SUBJECT: CRYSTAL RIVER UNIT 3 - ISSUANCE OF AMENDMENT RE: PRESSURE/
TEMPERATURE CURVES (TAC NOS. 75304 AND 71483)

CRYSTAL RIVER UNIT 3 NUCLEAR GENERATING PLANT
AMENDMENT TO FACILITY OPERATING LICENSE

Amendment No. 133
License No. DPR-72

SAFETY EVALUATION BY THE OFFICE OF NUCLEAR REACTOR REGULATION
SUPPORTING AMENDMENT NO. 133 TO FACILITY OPERATING LICENSE NO. DPR-72
FLORIDA POWER CORPORATION, ET AL.
CRYSTAL RIVER UNIT NO. 3 NUCLEAR GENERATING PLANT
DOCKET NO. 50-302

Figure 3.4-2

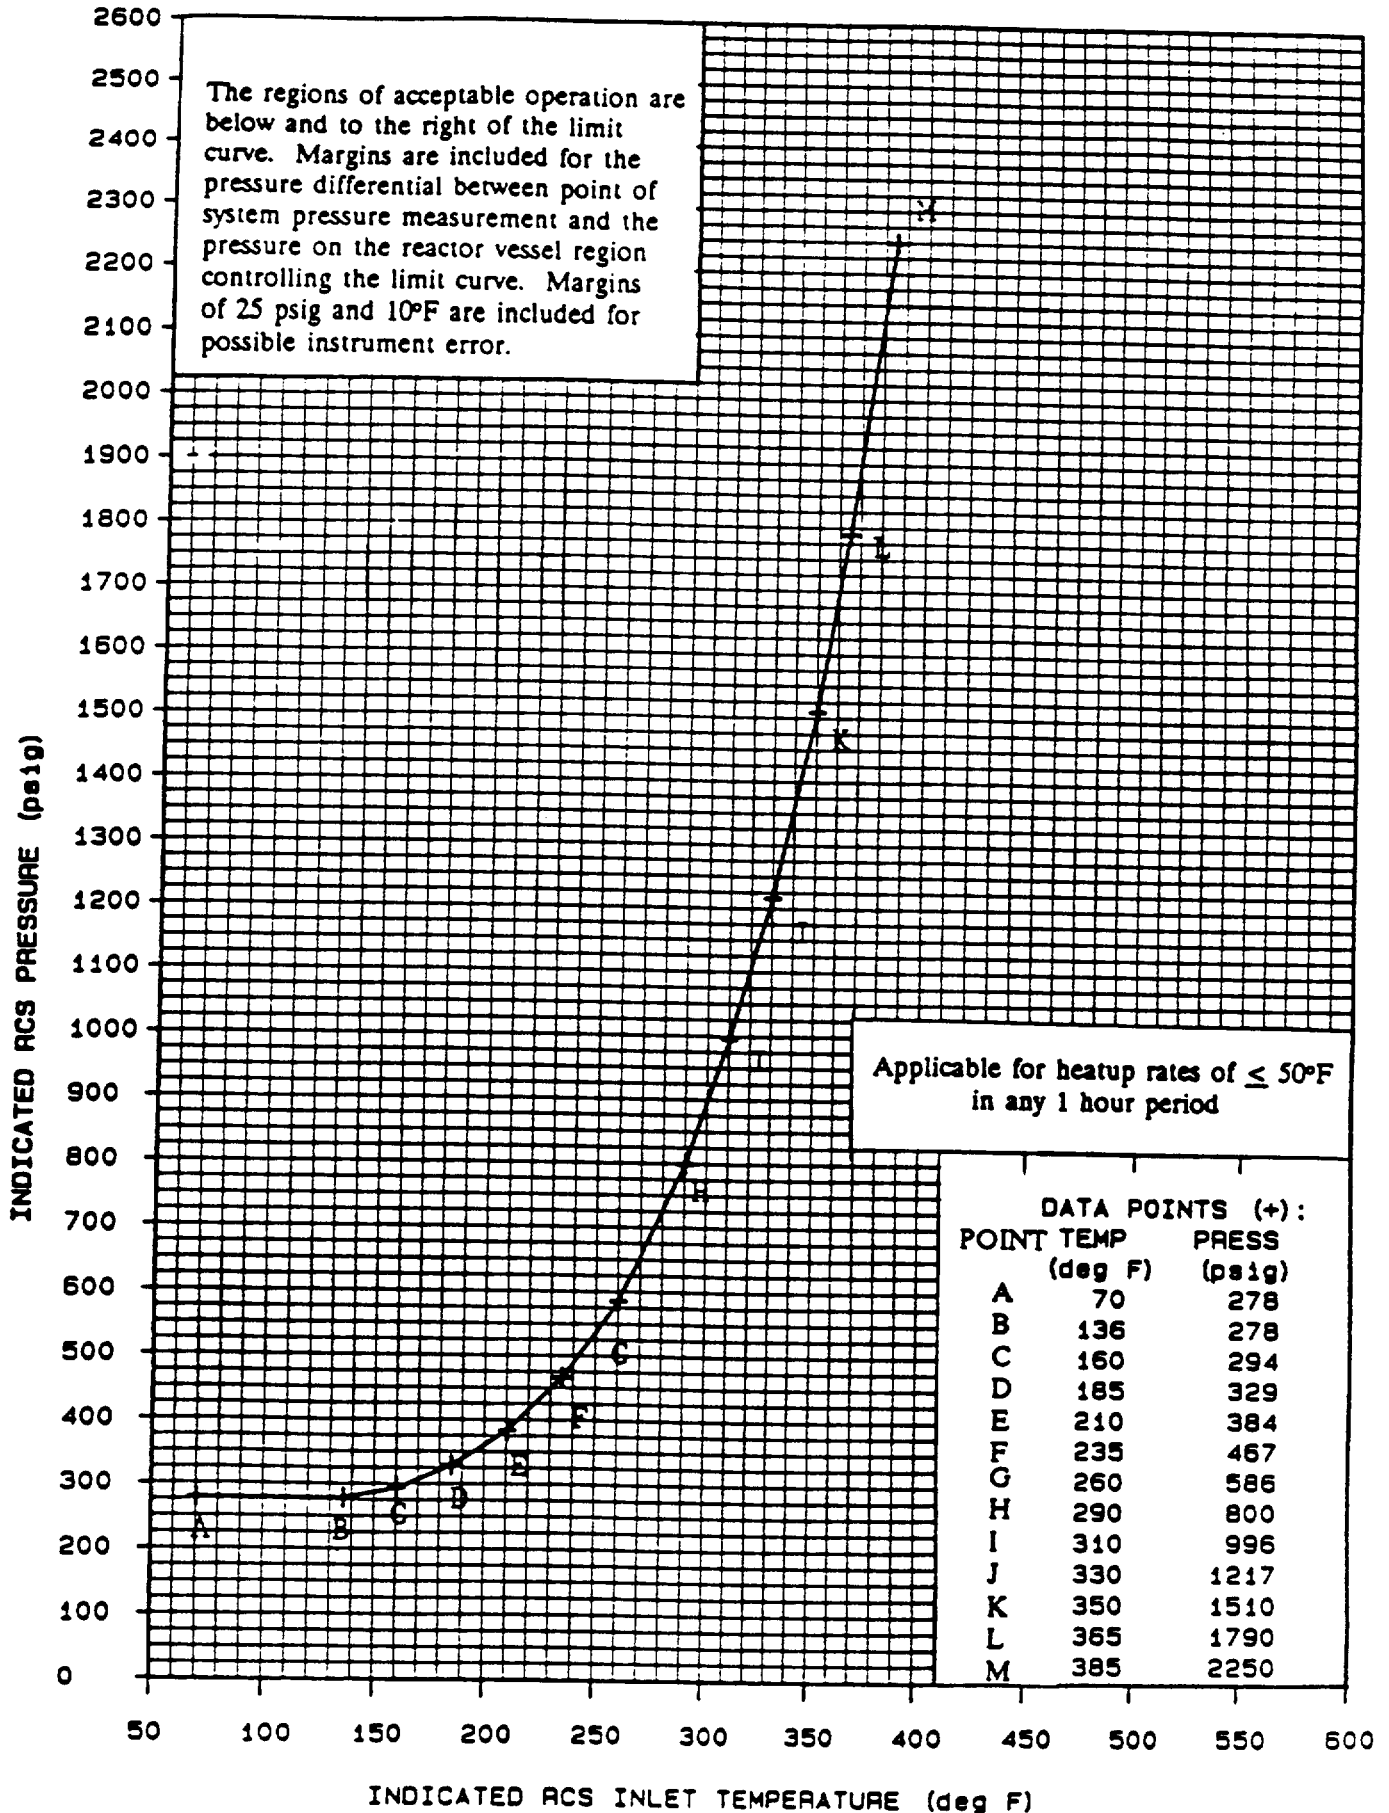
This amendment revises Technical Specification 3.4.9.1, including Figures 3.4-2, 3.4-3, and 3.4-4. This revision provides reactor coolant system heatup and cooldown pressure/temperature (P/T) curves for operation up to 15 effective full power years.

3.4.9.1 The Reactor Coolant System (except the pressurizer) temperature and pressure shall be limited in accordance with the limit lines shown on Figures 3.4-2, 3.4-3, and 3.4-4 during heatup, cooldown, and inservice leak and hydrostatic testing with:

The heatup limit curve, Figure 3.4-2, is a composite curve which was prepared by determining the most conservative case, with either the inside or outside wall controlling, for any heatup rate up to 50°F per hour. During cooldown, similar types of thermal stress occur. Thus, the cooldown limit curve, Figure 3.4-3, is also a composite curve which was prepared based upon the same type analysis as the heatup curve with the exception that the controlling location is always the inside wall where the cooldown thermal gradients tend to produce tensile stresses while producing compressive stresses at the outside wall.

For the limiting beltline material, weld WF-70, the staff calculated the ART to be $191.1^{\circ}F$ at $1/4T$ (T = reactor vessel beltline thickness) and $141.4^{\circ}F$ for $3/4T$ at 15 EFY.² The staff used a neutron fluence of $2.99E18$ n/cm^2 at $1/4T$ and $1.08E18$ n/cm^2 at $3/4T$. The ART was determined by Section 1 of RG 1.99, Rev. 2.

Based on the above evaluation, the staff concludes that the proposed changes to the P/T limits for up to 15 EFPY are acceptable.
